SERVICE BULLETIN

Buell[®]
AMERICAN MOTORCYCLES

B-032

PRODUCT PROGRAM BP7 - EXHAUST HEADER MOUNT RETROFIT KIT

Figure 1. Modified Exhaust Mounting System (1999-2000 Models)

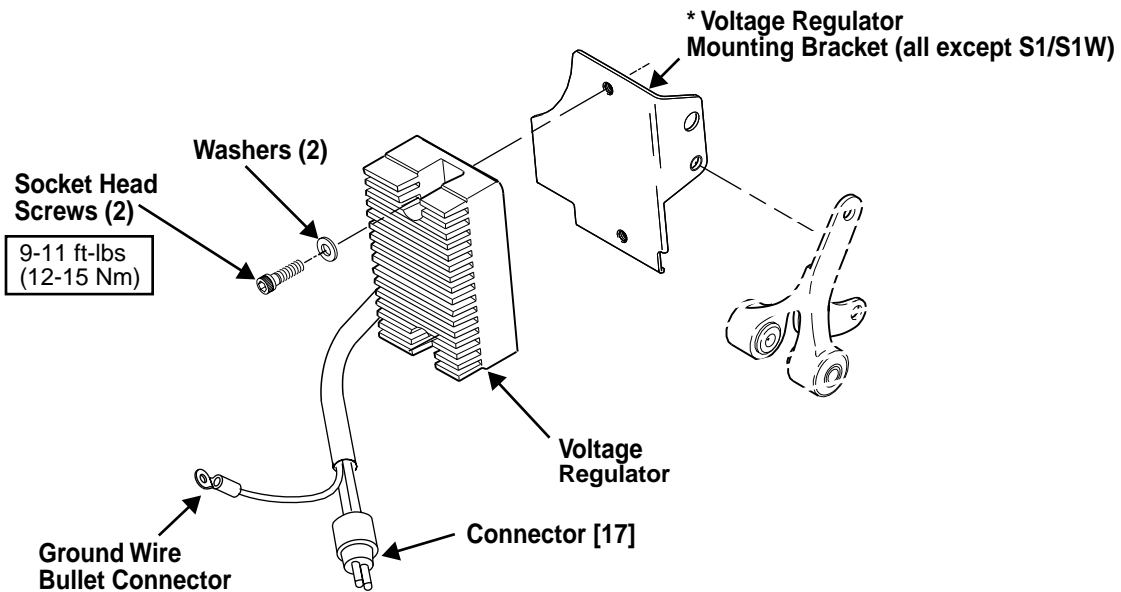
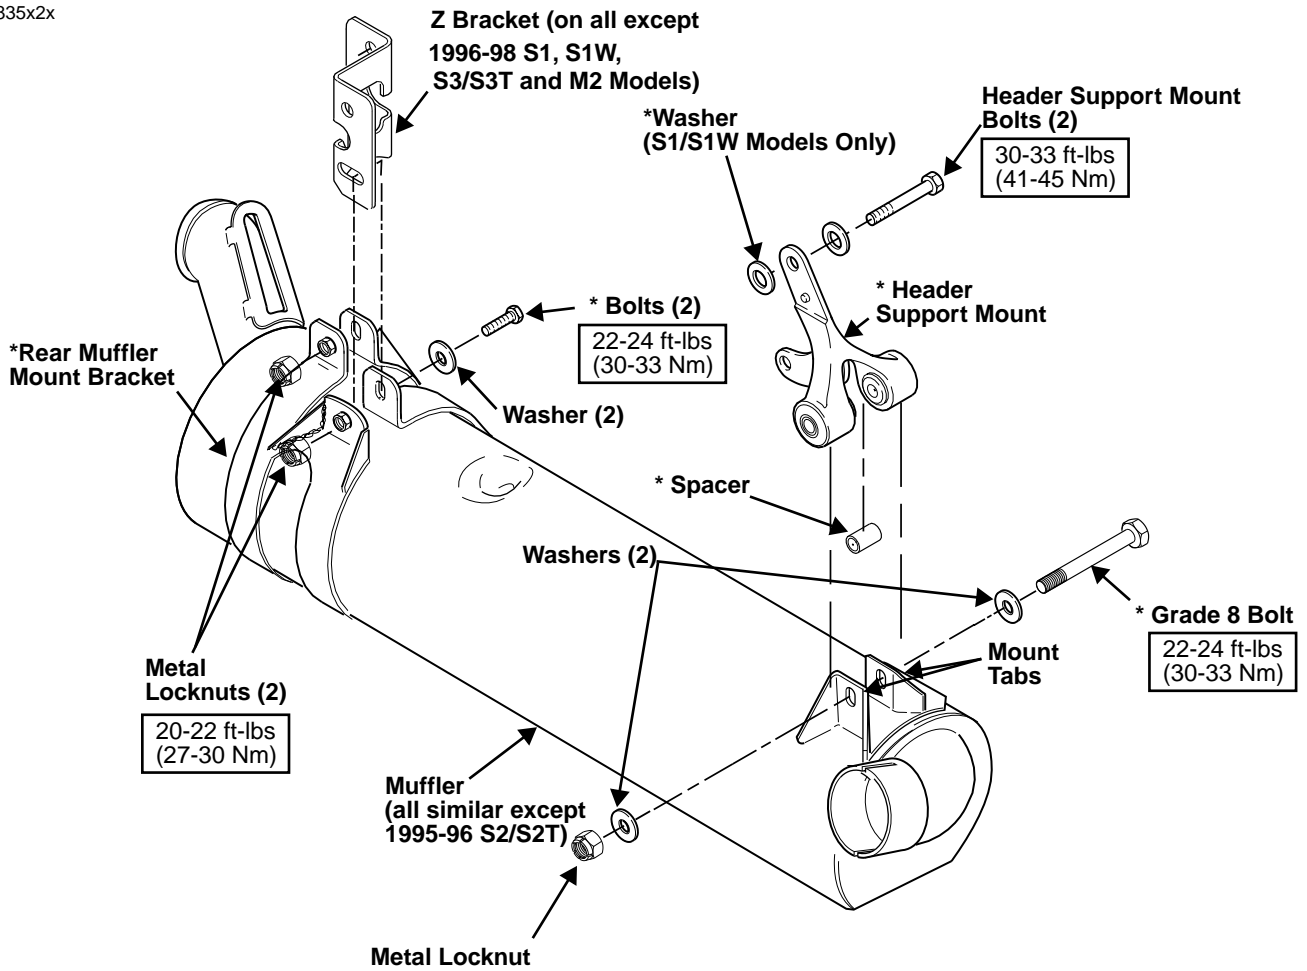
The purpose of this bulletin is to announce the release of a **new** kit for all 1995-2000 S1, S1W, M2, S2/S2T, S3/S3T, and X1 Model Buell motorcycles and to provide installation instructions. Buell Motorcycle Company has developed this kit as an upgrade to the exhaust header mounts currently in use.

9. Install **new** voltage regulator bracket to **new** header support mount and install to crankcase/muffler.

10. **S1/S1W Models Only:** See Figure 1. Install **new** washer (provided in kit) over hole at top of the header support mount (between header support mount and crankcase). Install header support mount with two original header support mount bolts and washers.

12. **1999-2000 Models Only:** See Figure 1. Remove and discard muffler mount from rear of muffler and install **new** muffler mount.
 - a. Remove two screws, lockwashers and washers from rear exhaust mount and Z bracket. Discard screws and lockwashers. Retain washers for reuse.

- c. See Figure 1. Apply LOCTITE THREADLOCKER 243 (Blue) to threads of two original header support mount bolts. Install voltage regulator bracket/header support assembly with two original header support mount bolts and washers (and locknuts if present). DO NOT tighten.
 - d. Apply LOCTITE THREADLOCKER 243 (Blue) to threads of original small button head allen screw and install to voltage regulator bracket and shock mounting bracket. DO NOT tighten.
 - e. See Figure 4. Check voltage regulator bracket to verify that pin remains engaged in hole and that bracket does not pivot front to rear.

- b. Push rear of muffler down slightly and remove (slide off) and discard original rear muffler mount bracket.
 - c. Slide **new** rear muffler mount bracket over muffler and install with two **new** grade 8 bolts (provided in kit), original washers and **new** metal locknuts. NOTE: Install two metal locknuts over weldnuts on right side.

- d. Tighten rear muffler mount bracket bolts to 22-24 ft-lbs (30-33 Nm).
 - e. Tighten rear muffler mount bracket metal locknuts to 20-22 ft-lbs (27-30 Nm).

Figure 2. Original Exhaust Header Mount (1999-2000)

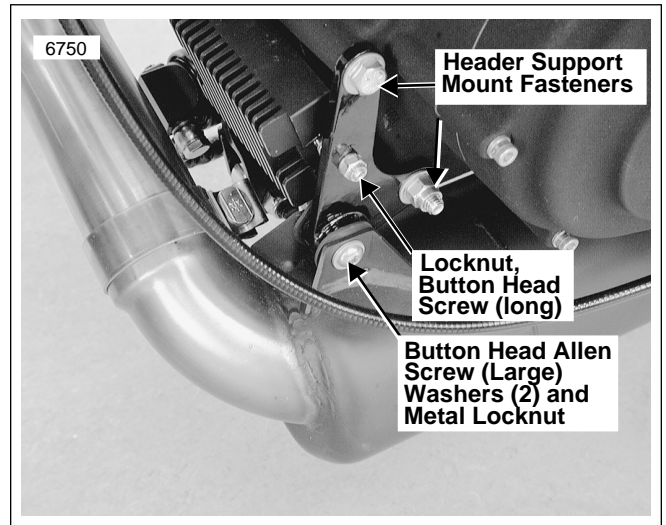
6. See Figure 3. Position bottle jack under swing arm mount block and raise motorcycle just enough to unload rear suspension (rear wheel remains on lift).
7. Remove and discard header support mount from muffler and crankcase.
 - a. See Figure 2. Remove large button head allen screw, two washers and metal locknut from header support mount. Discard screw. Retain washers and locknut for reuse.

- b. See Figure 2. Remove two header support mount bolts, washers, locknuts (if present) and header support mount, allowing shock mounting bracket (attached to front shock eye) to hang free. Discard header support mount. Retain washers and two bolts.
8. Inspect muffler inlet, O₂ sensor bung (if present), mounts and fasteners for cracks or damage. Replace damaged parts as required. See Credit Procedure.

Figure 4. Voltage Regulator Bracket

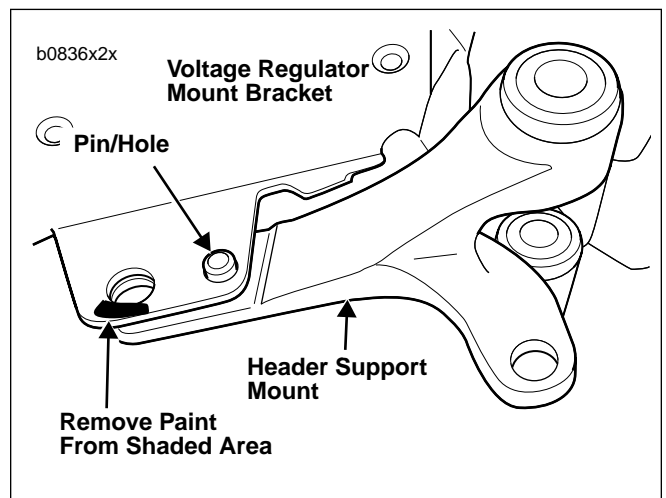
Scraping the paint from the voltage regulator bracket is required to ensure a good ground for the voltage regulator.

- a. See Figure 4. Scrape paint from inside corner of voltage regulator bracket on crankcase side.
- b. See Figure 4. Position **new** header support so pin engages hole in new voltage regulator bracket.

Figure 5. Header Support Mount (all except S1/S1W)

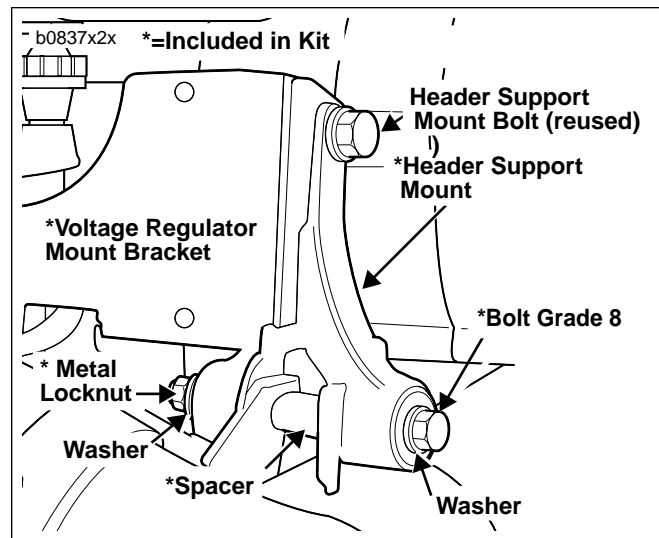
11. See Figures 1 and 5. Install **new** grade 8 bolt, original washer, **new** spacer, original washer and metal locknut to header support mount. NOTE: Spacer goes between front muffler mount tabs.

13. Tighten header support mount fasteners.
 - a. Tighten two header support mount bolts to 30-33 ft-lbs (41-45 Nm).
 - b. Tighten button head allen screw to 9-11 ft-lbs (12-15 Nm).

- c. Tighten front muffler mount bolt to 22-24 ft-lbs (30-33 Nm).
14. Lower and remove bottle jack from motorcycle.

Figure 6. Voltage Regulator Revised Mounting

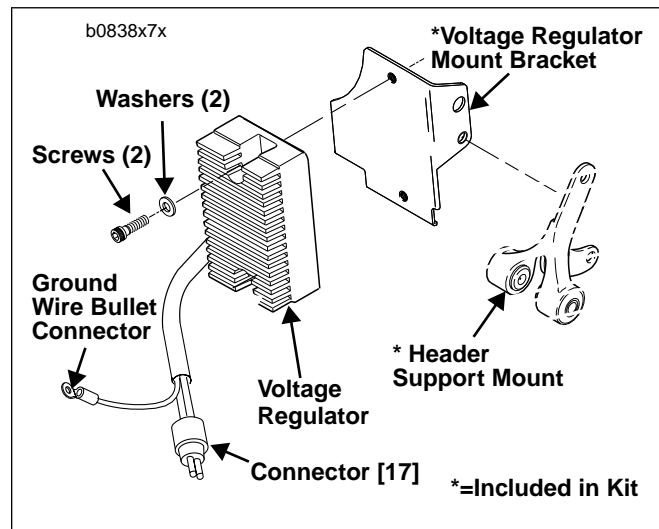
15. See Figure 6. Install voltage regulator.
 - a. Install voltage regulator to **new** bracket with original socket head screws and washers. Tighten screws to 9-11 ft-lbs (12-15 Nm).
 - b. See Figure 7. Route voltage regulator wire harness between shock mounting bracket and oil line.
 - c. See Figure 8. Mate connector [17] halves and secure with cable tie.
 - d. See Figure 6. Connect ground wire bullet connector to main wire harness.
 - e. See Figure 8. Push connector [17] behind gearcase cover and secure connector [17] to oil pump fitting with cable tie.
 - f. See Figure 8. Secure voltage regulator wire harness to oil line and oil pressure switch harness with cable tie.
16. Reconnect battery negative cable to negative terminal. Tighten terminal to specification given in service manual for model being serviced.
